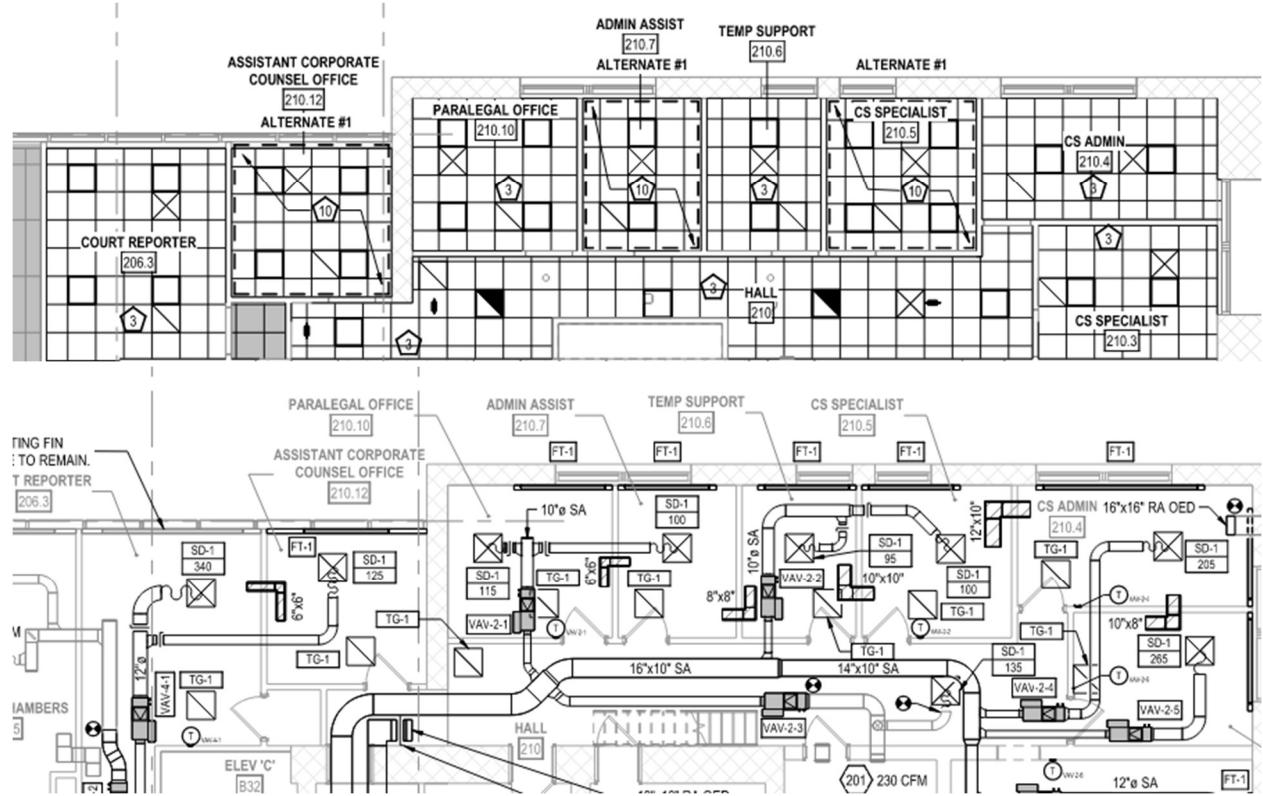
1 There are VAV's serving both base bid and alternate offices. Please clarify how we are to price. Same with transfer ducts. See below for an example:

a. The VAV replacement, supply ductwork and transfer ductwork is in the base bid, the ceiling work in rooms 210.10 and 210.6 in this example are in the base bid due to the need to remove the ceiling to install the VAV, ceilings in Alt#1 may remain, with new diffusers and grilles.
